Rapiscan systems	Secure 1000 Radiation Emission Measurement	FORM R-0646-1 (Single Pose)
----------------------------	---	--------------------------------

Re: Rapiscan AIT System Radiation Survey Reporting

R-0646-1 Addendum (Documentation Errors)

1. In Beam Dose Measurement: Survey Table. 1

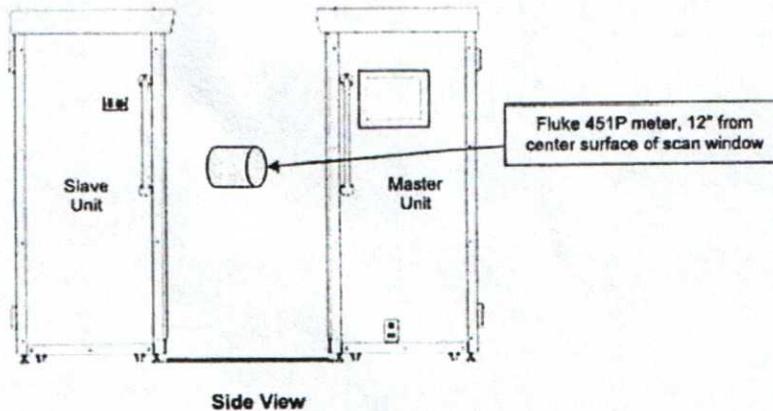
1. TABLE 1: Incorrect presentation of data in Column 3 for Measured Exposure. Indicated values are 15uR and 17uR. Corrected values are 1.5uR and 1.7uR. The values were corrected by technician when calculating Effective Dose.
2. TABLE 1: Incorrect presentation of data in Column 6 for Effective Dose. Indicated values are 8.6 uRem and 9.7uRem. Corrected values are .86 uRem and .97uRem
3. Based on review of survey by RSO, RSO determined that Technician incorrectly marked the fail check box.

CORRECTIVE ACTION

The service technician should attend refresher training.

The corrected data indicates this system was operating within expected parameters. No re-survey is required for this system.
